Project: WBS 42833.1.1 (B-5231)
 Bridge #162 on SR 1121 over Price Creek
 Yancey County

Subject: MINUTES OF MEETING

PURPOSE/DESCRIPTION:		Pre-Bid Meeting
DATE & TIME:		Wednesday, January 6, 2010 10:00 am
LOCATION:		NCDOT Bridge Management Unit Small Conference Room Raleigh, North Carolina
ATTENDEES		
Name	Representing	Telephone Number
	See Meeting Roster	
Jim Mondolfi	Ko/Florence & Hutcheson, Inc.	919-851-6066

APPROACH SLAB
 27'-0" CLEAR ROADWAY
 60° SKEW

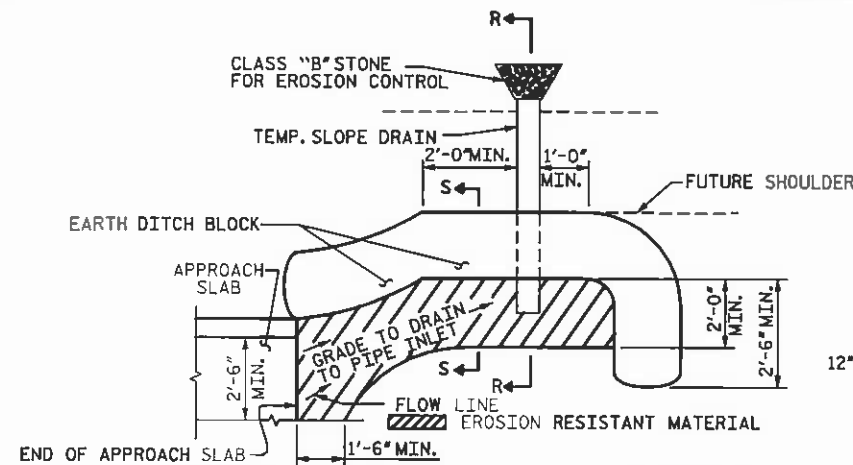
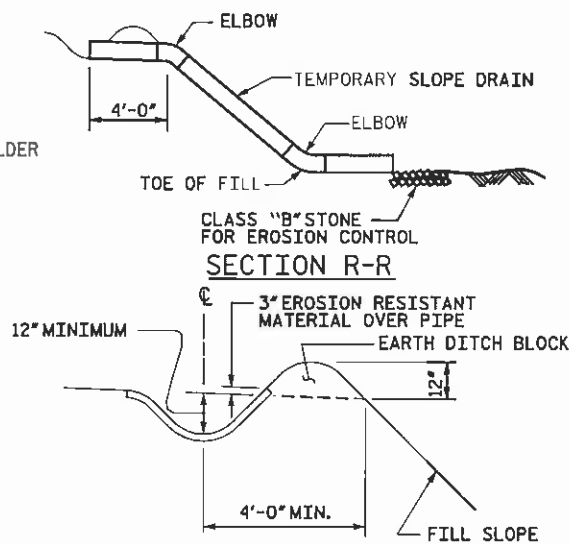
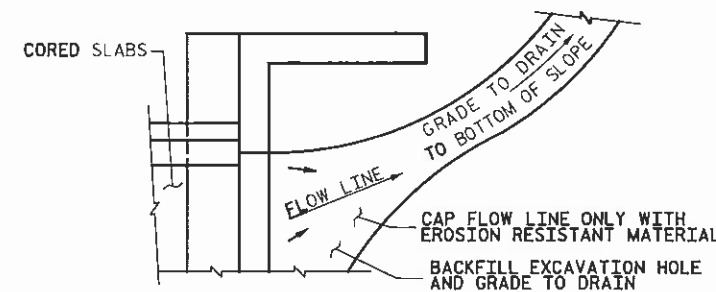
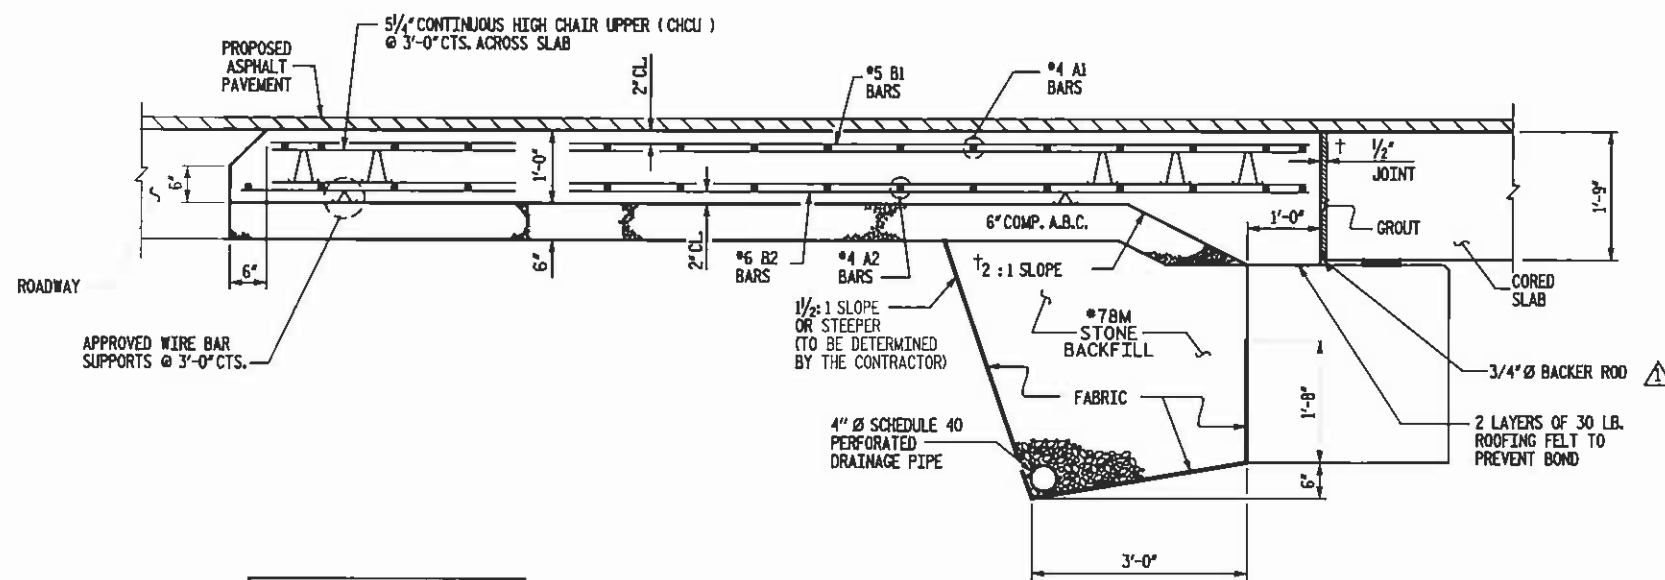
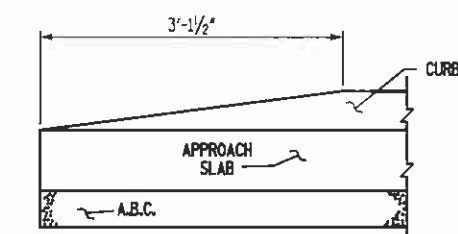
- REVISOR'S NOTES
- ADDED BACKER ROD NOTE
- REVISED TITLE BLOCK
